Re: 08ITB61876K-DB
S118 Big Creek WRF Effluent Filter Rehabilitation

Attached is one (1) copy of Addendum 2, hereby made a part of the above referenced Bid #08ITB61876K-DB, S118 Big Creek WRF Effluent Filter Rehabilitation.

08ITB61876K-DB
S118 Big Creek WRF Effluent Filter Rehabilitation
Addendum No. 2
Page 3 of 13

JORDAN JONES & GOULDING	EFFLUENT FILTERS REHABILITATION BIG CREEK WRF	PROJECT NO.: 2016.029 DATE: 06-16-08 SCALE: NONE
	SECTIONS	ADDENDUM NO.: 2 SHEET REVISED: P0.5 SKETCH NO.: P-1

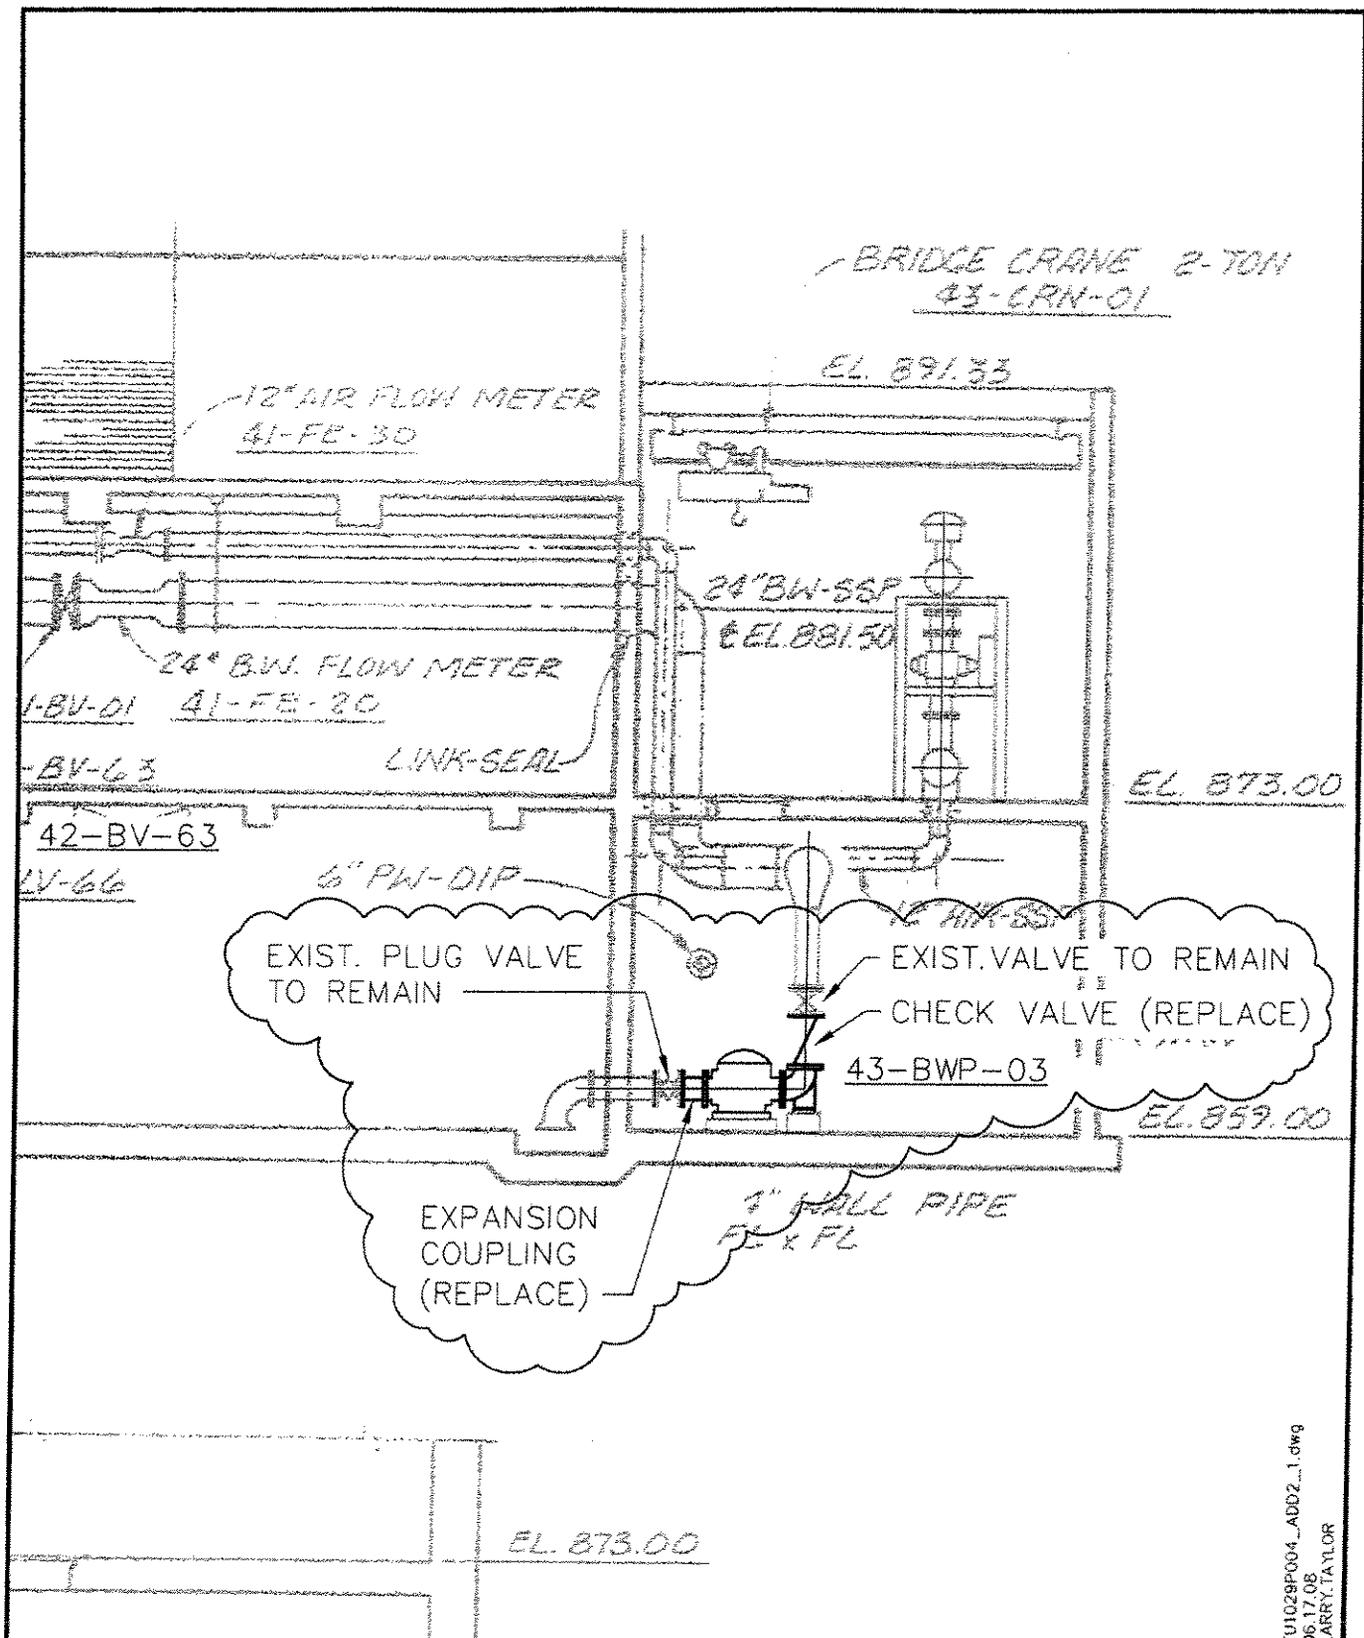
Item 9. Revise Sheet P0.5 in accordance with Sketch P-1 included with this addendum.

RESPONSE: Yes. See Addenda Item 9 in Modifications to Drawings and Specifications above.
4. **QUESTION:** Are we required to replace existing conduit where it does not meet the specifications of this project?

11. **QUESTION:** The P & ID drawing number I0.9 shows no new piping or valves on the suction side of the three new Backwash pumps. The process drawing P0.5 seems to indicate that the existing plug valve AND the expansion joint get replaced on each of the three pump suction lines. Which drawing is correct?

12. **QUESTION:** The P & ID drawing number I0.9 shows no new gate valves on the discharge side of the three new Backwash pumps. The process drawing P0.5 appears to indicate that the existing gate valve gets replaced on each of the three pump discharge lines. Which drawing is correct?

PROJECT NO.: 2016.029
DATE: 06-16-08
SCALE: NONE
ADDENDUM NO.: 2
SHEET REVISED: P.08
SKETCH NO.: P-2

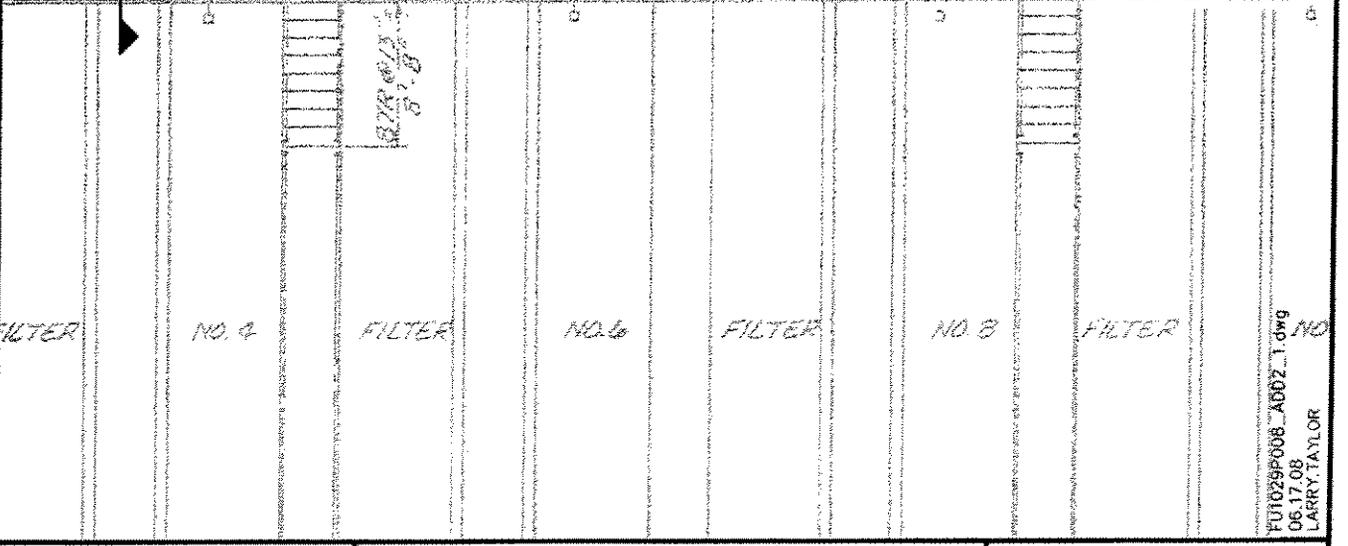
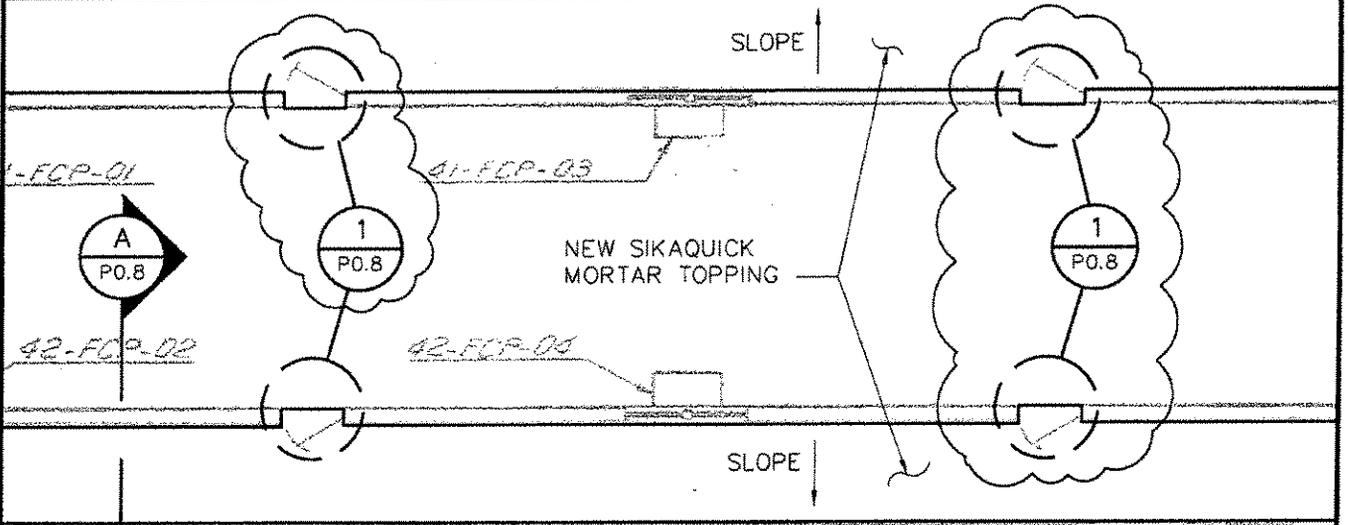
- Item 11. Revise Drawing P0.8 in accordance with Sketch P-2 included with this addendum.

RESPONSE: Only if clearly indicated on the drawings as conduit to be removed and replaced. In general where not indicated conduit is to be reused.
5. **QUESTION:** Reference sheet P0.8. Which doors are to be replaced (only one is indicated)?

RESPONSE: See Addenda Item 11 in Modifications to Drawings and Specifications above.
6. **QUESTION:** Reference sheet P0.8. Would we be allowed to replace the whole door frame in lieu of modifying the existing frame as indicated?

8. **QUESTION:** Sheet P0.8, Section 1 details existing door modifications. We assume that this is not "typical" and only occurs at one door. Also in reference to this detail, we assume that the door modifications will be part of the alternate 1 price. Please confirm.

RESPONSE: See response to Question No. 5, above. Four doors are to be replaced and frames modified. All work shown on Sheet P0.8 is to be included in the alternate 1 price.

PROJECT NO.: 2016.029
 DATE: 06-16-08
 SCALE: NONE
 ADDENDUM NO.: 2
 SHEET REVISED: P0.2
 SKETCH NO.: P-3

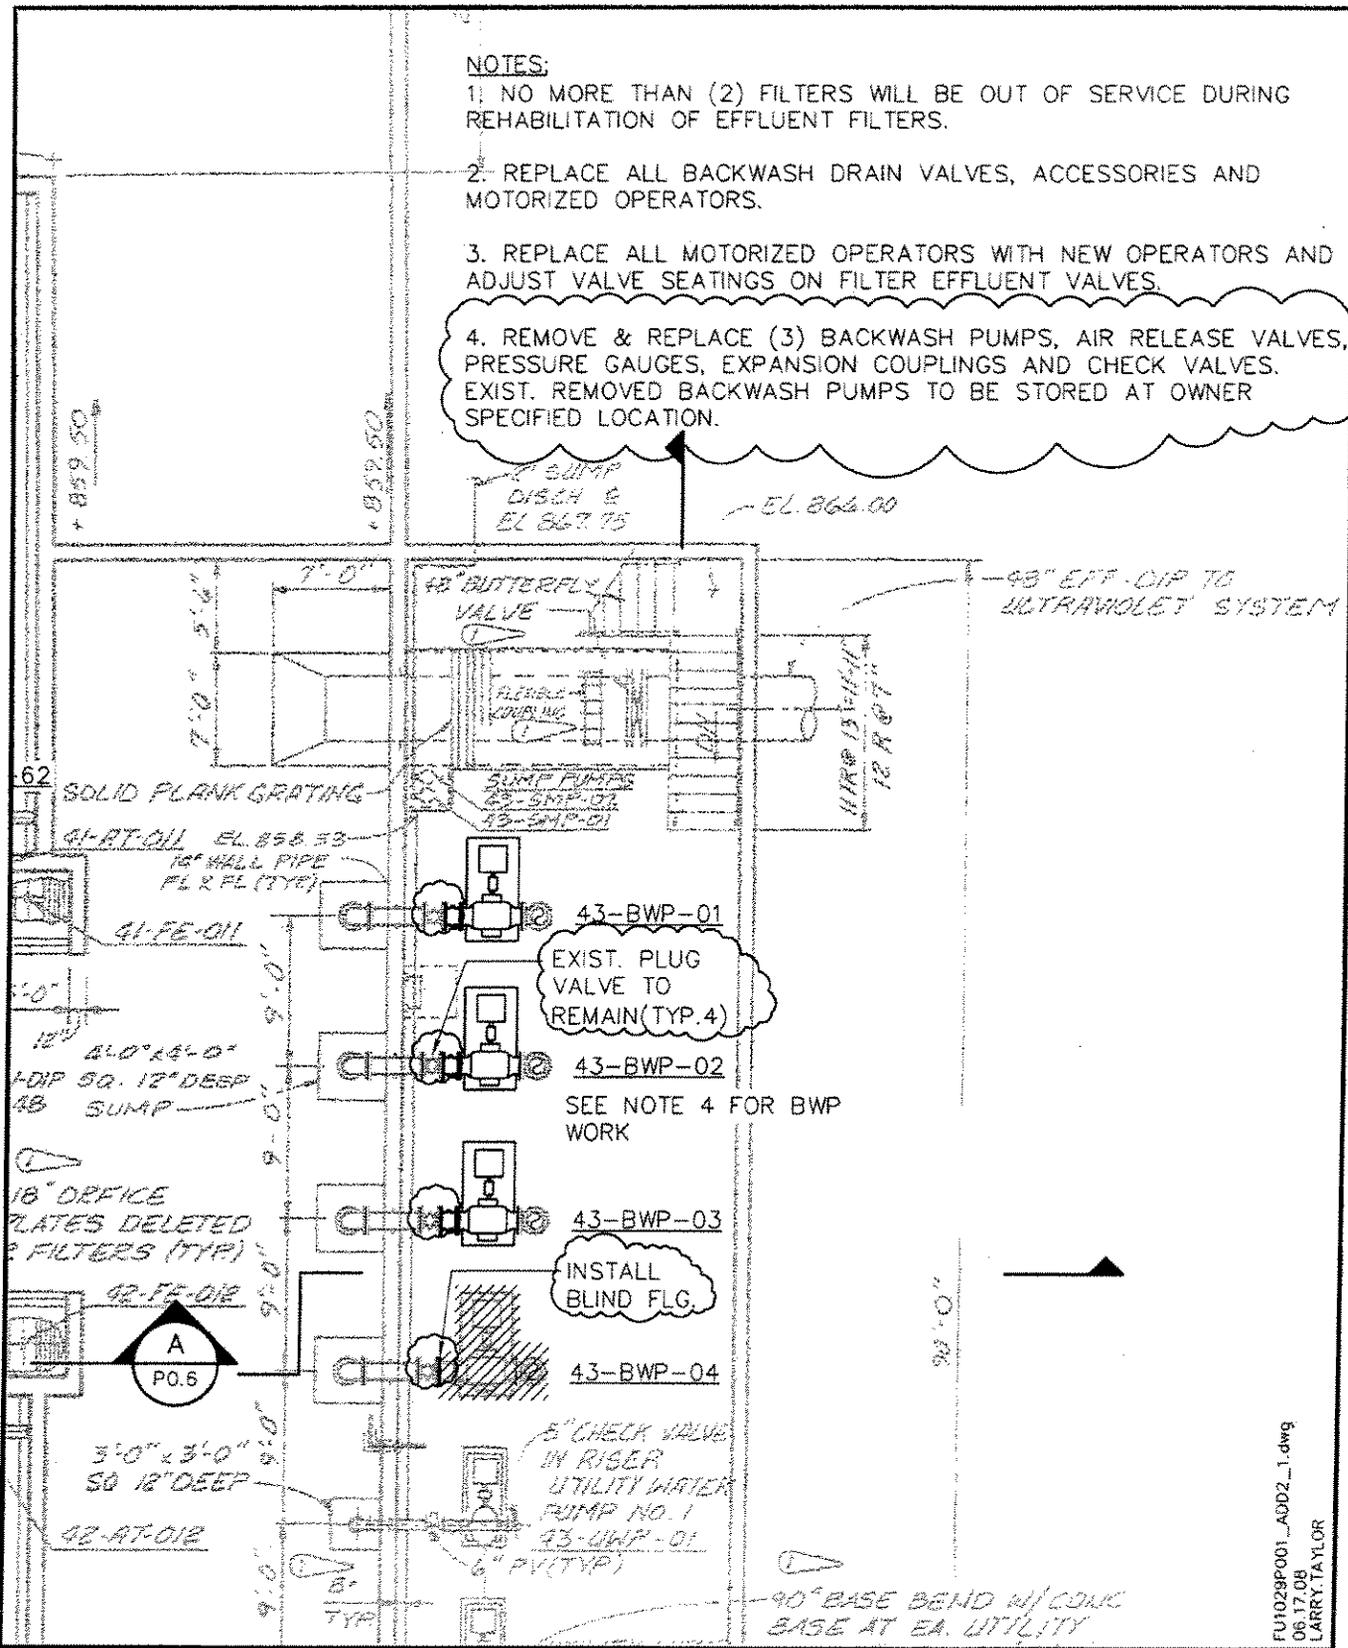
Item 8. Revise Sheet P0.2 in accordance with Sketch P-3 included with this addendum.

13. **QUESTION:** Drawing P0.2 note 3 seems to indicate that only the check valves get replaced and NOT the suction plug valve nor the discharge gate valve on the backwash pump pipe lines. Is this a correct assumption?

14. **QUESTION:** Do the existing Air Release valves that are on the split case backwash pumps get reinstalled on the new Backwash pumps?

15. **QUESTION:** Do the existing gauges on the existing Backwash pumps get reinstalled on the new Backwash pumps?

17. **QUESTION:** Are the 12" flanged expansion joints on the backwash pumps to be reused or are new ones to be provided? If new expansion joints are to be provided, please provide specifications.

2. REPLACE ALL BACKWASH DRAIN VALVES, ACCESSORIES AND MOTORIZED OPERATORS.

3. REPLACE ALL MOTORIZED OPERATORS WITH NEW OPERATORS AND ADJUST VALVE SEATINGS ON FILTER EFFLUENT VALVES.

4. REMOVE & REPLACE (3) BACKWASH PUMPS, AIR RELEASE VALVES, PRESSURE GAUGES, EXPANSION COUPLINGS AND CHECK VALVES. EXIST. REMOVED BACKWASH PUMPS TO BE STORED AT OWNER SPECIFIED LOCATION.

PROJECT NO.: 2016.029
DATE: 06-16-08
SCALE: NONE
ADDENDUM NO.: 2
SHEET REVISED: 10.9
SKETCH NO.: 1-1

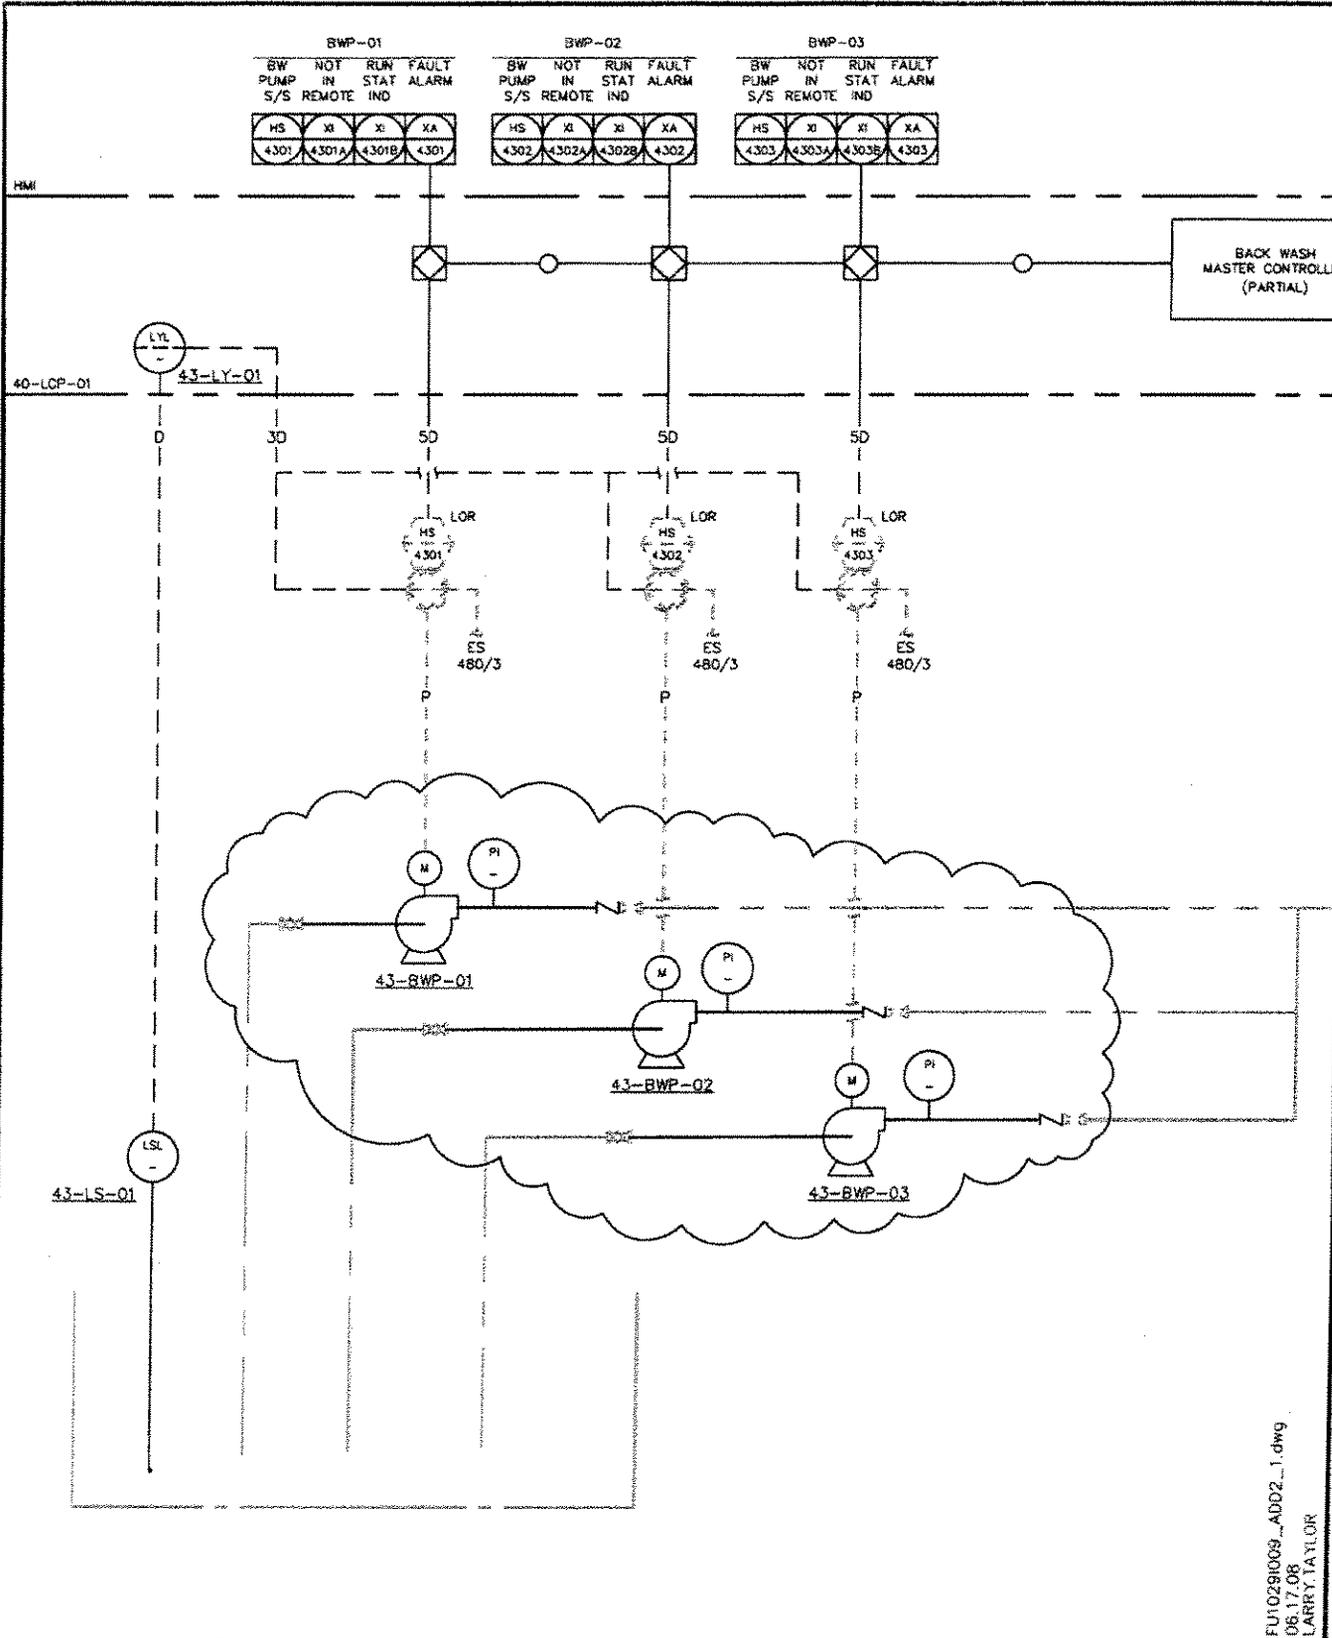
- Item 12. Revise Sheet I0.9 in accordance with Sketch I-1 included with this addendum.

10. **QUESTION:** The P & ID drawing number I0.9 shows what looks like a backpressure valve on the discharge side of the Backwash pumps. This valve is not shown on the process drawings. Is this valve required in all three pump discharges?

23. QUESTION: Drawing I0.9, backwash pumps – a pressure gauge is shown on the discharge of each pump. Please provide specifications for these gauges. A pressure control valve is also shown; please provide specifications for these valves.

28. **QUESTION:** Sheet I0.9 – Backwash Pumps 43-BWP-01, -02, -03: What is the symbol shown in each of the pump discharge pipes immediately downstream of the pressure gauges? Do they indicate a type of valve to be included in the scope of work, in addition to the new cushioned check valves?
